**Environmental Assessment of  
Ground Water Compliance at the  
Shiprock Uranium Mill Tailings Site**

**Final**

**September 2001**

Prepared by  
U.S. Department of Energy  
Grand Junction Office  
Grand Junction, Colorado

Figure 2. Physiographic Block Diagram of the Shiprock Site

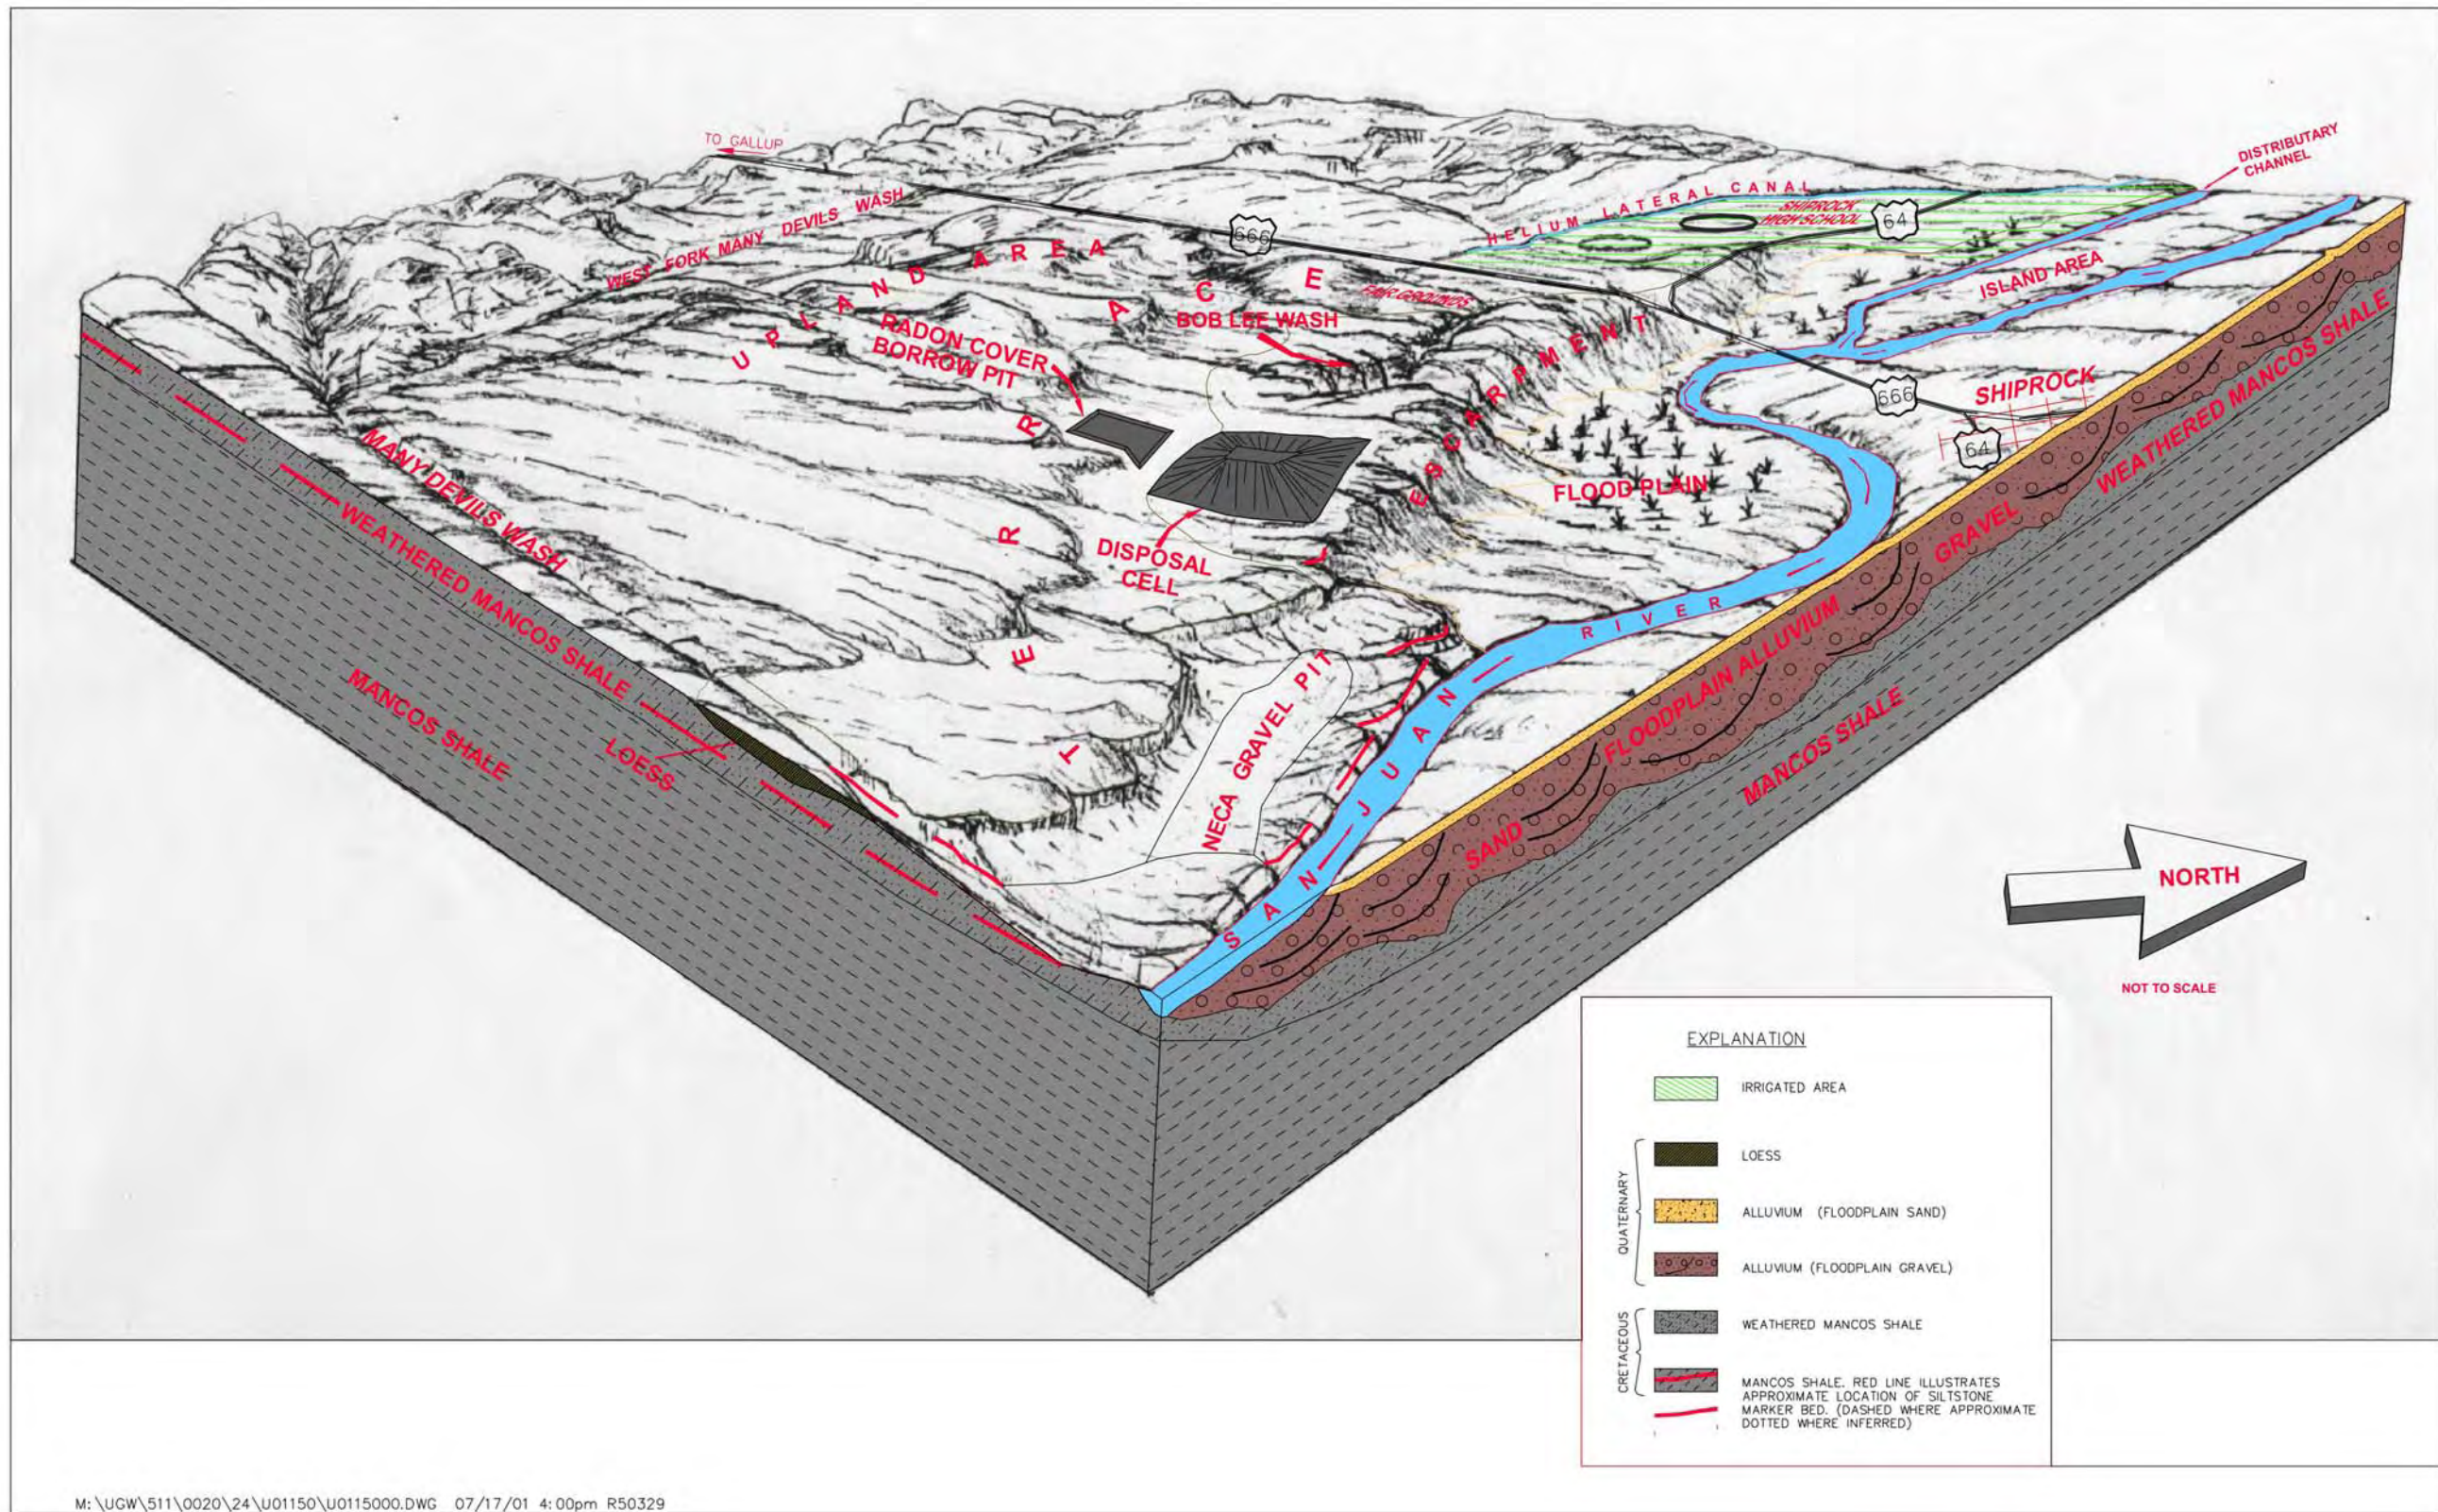
EA Comments <sup>a</sup>		Issue Type <sup>b</sup>	Status <sup>c</sup>	Response/Resolution
89	p.5, Figure 2: The map may not be to scale, but the cross-section showing the geologic features should be somewhat realistic. Alluvial sediments generally do not lie flat when deposited; rather, the stream profile should indicate the flow characteristics from channeling caused by erosion and deposition.	T	A	Some bedding surfaces will be added to Figure 2 in an attempt to show the channeling in the alluvial material.
90	p. 6: There is no page 6.	S	NC	Page 6 is the back of page 5. All color figures are printed separately on a color printer. Running the figures through again to print the even page numbers on the reverse side would add considerable time and expense to the preparation of the report. Also, if pages with color figures are used for two-sided printing, the text tends to burn through onto the figure.

Figure 3. July 1986 Aerial Photograph Looking Southeast at the Shiprock Site.

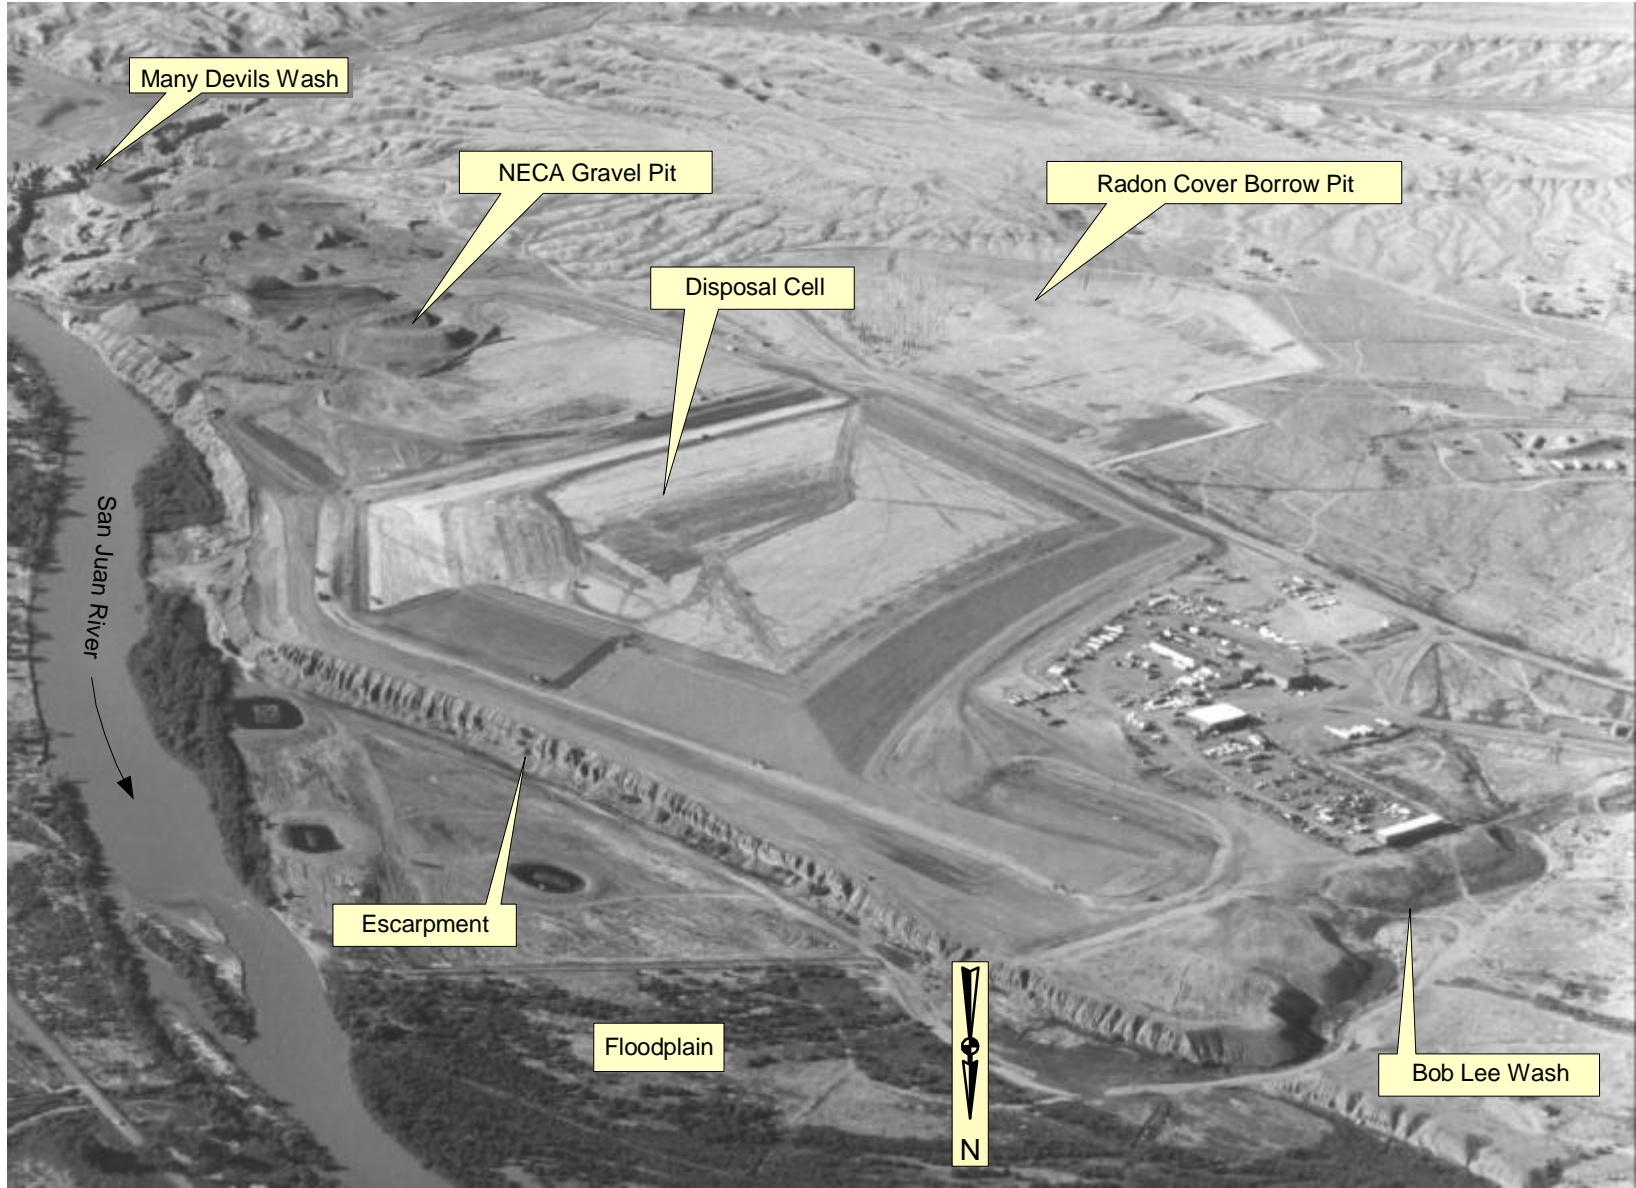
91	p.7, Figure 3: Change caption to “Looking Southeast from Northwest.”	T	A	The caption will be changed.
92	p.9, para. 1, first sentence: “Monitoring over the past 15 years....” Please indicate which wells or areas were sampled, since those wells located near the river may have been sampled during low river flows and re-sampled during high flows, causing the concentrations to dilute.	T	NC	Concentrations of antimony and cadmium were plotted historically for wells 732 through 736 along the San Juan River. For Sb, concentrations were consistently low after 1996 in low- and high-flow times of year. For Cd, concentrations were consistently low after 1994 in both low- and high-flow times of the year.
93	p.9, para. 1, second sentence: Is DOE still using both EPA and Navajo EPA standards? If both, then indicate with citations throughout the document when Navajo ground water standards were considered.	R	A	DOE will revise the EA to include “Navajo surface water standards.” The Navajo Nation does not currently have ground water standards other than those applied by 40 CFR 192. DOE appreciates the Navajo Department of Water Resources bringing this error to our attention.

Figure 5. Ground Water Compliance Selection Framework for the Terrace East Area

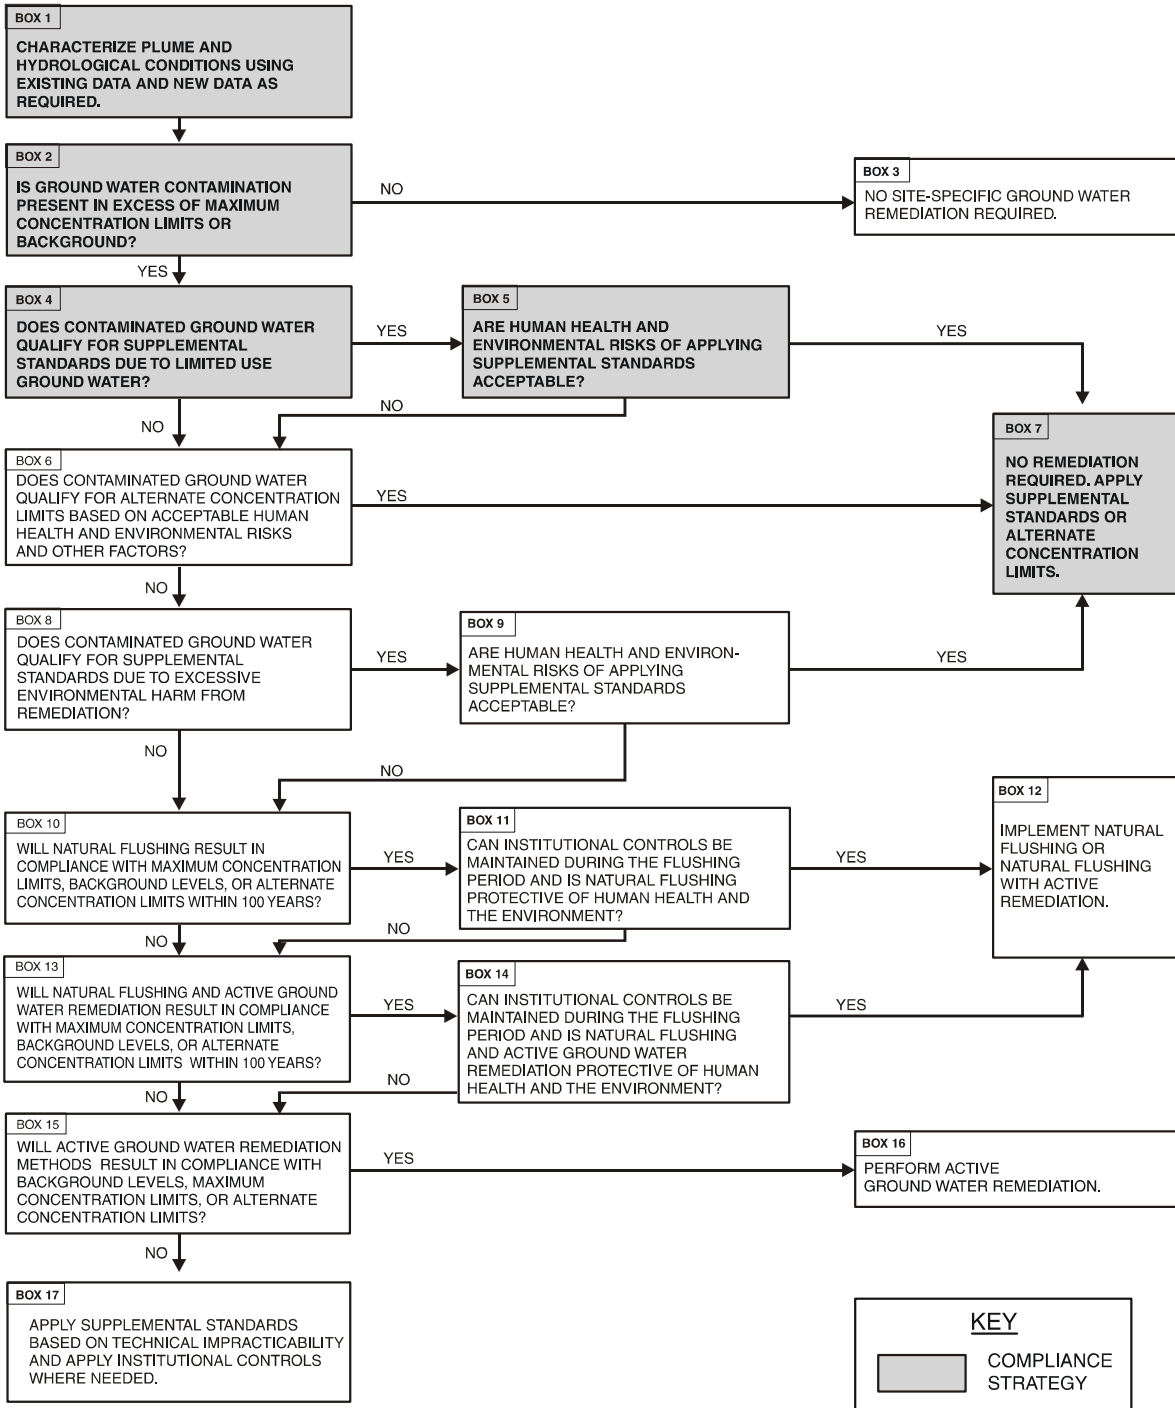
46	Figure 5: The same symbol (*) references two different notes, making this figure confusing unless both notes are supposed to be referenced each time.	S	A	Agree. This will be changed in the EA. Remove the “* Strategy will be reevaluated if conditions change or if monitoring indicates that EPA standards will not be met.”

Figure 22. Wetland and Vegetation Locations at the Shiprock Site

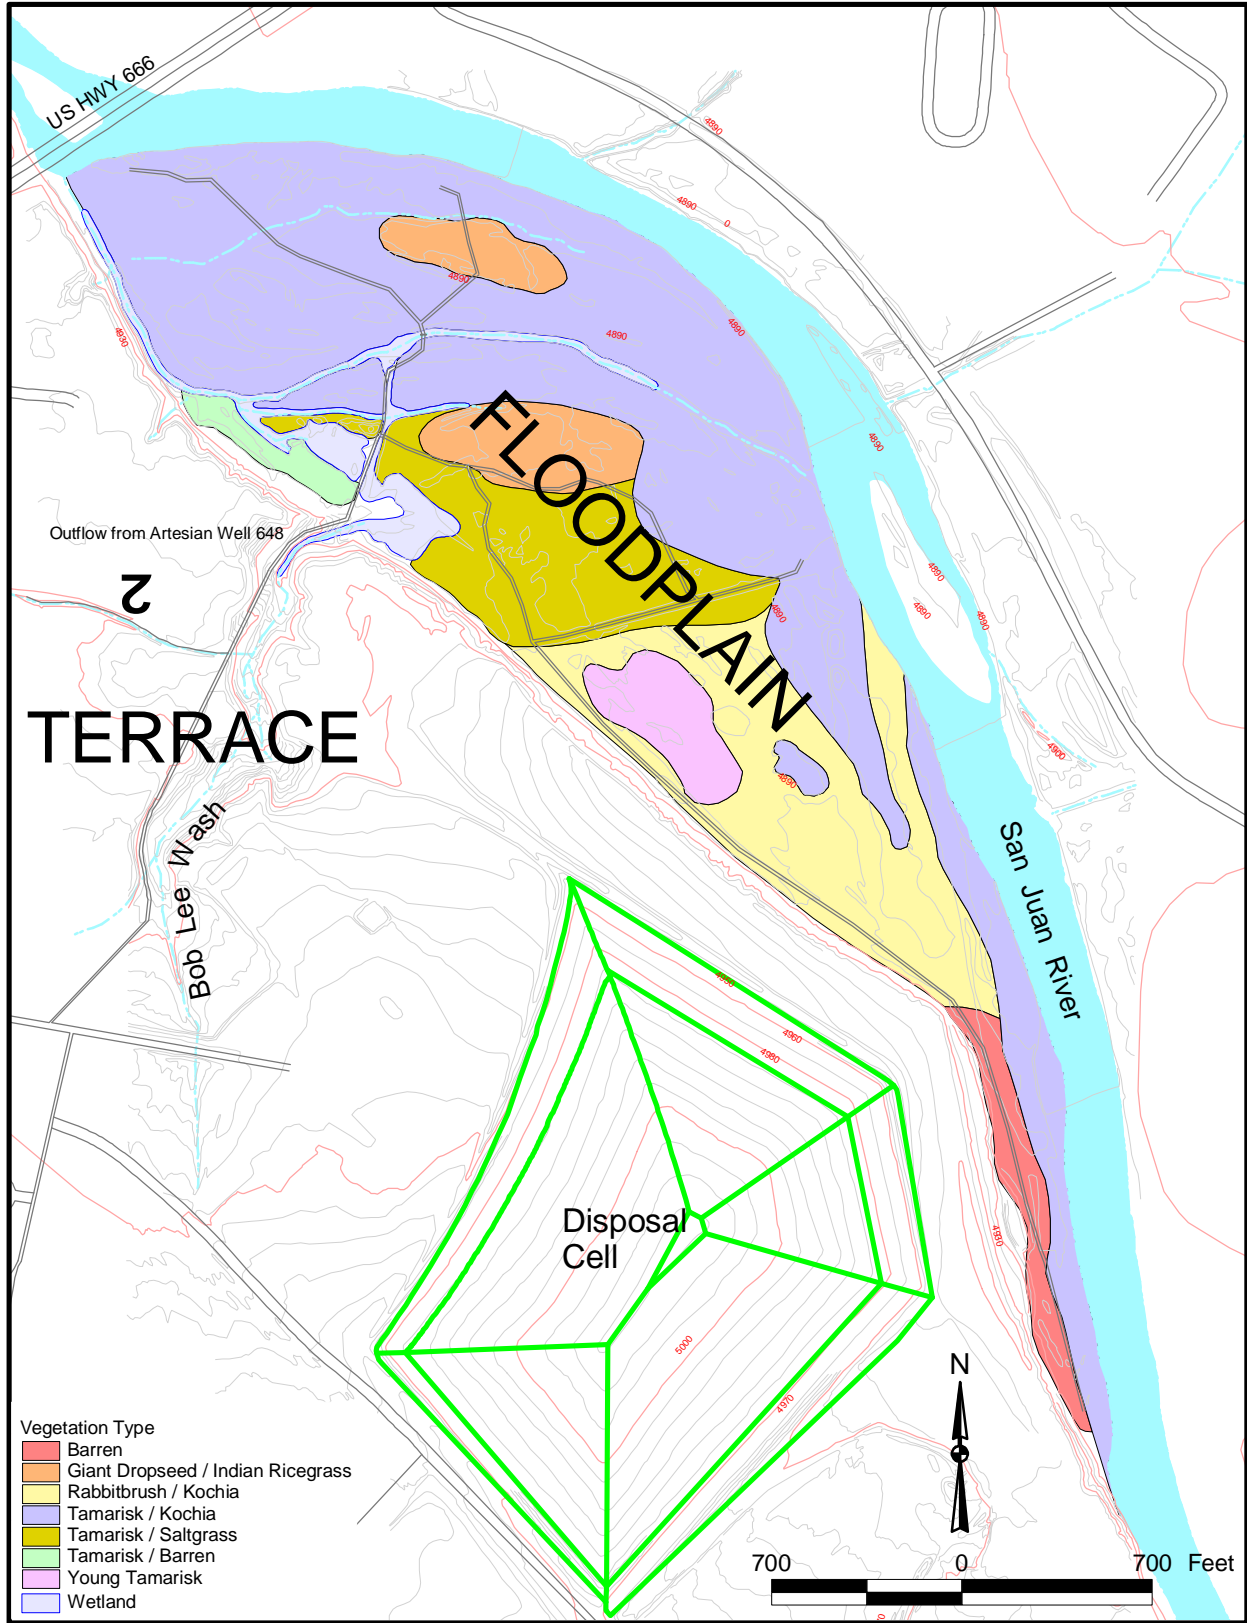
62	Sec. 4.3.1, para. 1, p.53: It is unclear whether Bob Lee Wash would be considered part of terrace east, but portions of that wash other than those delineated in EA Figure 22 would likely be considered jurisdictional wetlands, in contrast to the statement made in this paragraph.	R	NC	The jurisdictional wetlands was delineated in accordance with Corps of Engineers criteria. Due to potential conflicts with historical grazing rights, DOE has suggested to Navajo regulatory agencies that the wetlands be provided protected status if the Navajo Nation wishes to promote wetland values. To date a final response has not been received.
63	Sec. 4.4.2, Terrace West Area, p.71: Is the water clean enough for people to eat food such as beans, leaf lettuce, or fruit from an orchard (without washing first) if those plants have been watered with a sprinkler irrigation system? What if the yield is sufficient for agricultural uses in the highly contaminated portions along the east side of terrace west? Any water that may be used for irrigation or watering of food crops will need to meet standards similar to drinking water standards.	T,R	A	Concentrations of selenium are high enough in terrace west ground water that they could accumulate in certain types of plants to levels that are higher than recommended for dietary intakes of some animal species. Selenium is the constituent present in terrace west ground water that has the greatest potential for bioaccumulation. Selenium is an essential nutrient for humans, though it can be toxic at higher than dietary levels. Selenium uptake by plants and fruits is highly variable and it is impossible to say, in the absence of site-specific and plant-specific data, whether the ground water is safe for irrigation use. It is recommended that some other source of irrigation water be used for watering food crops.
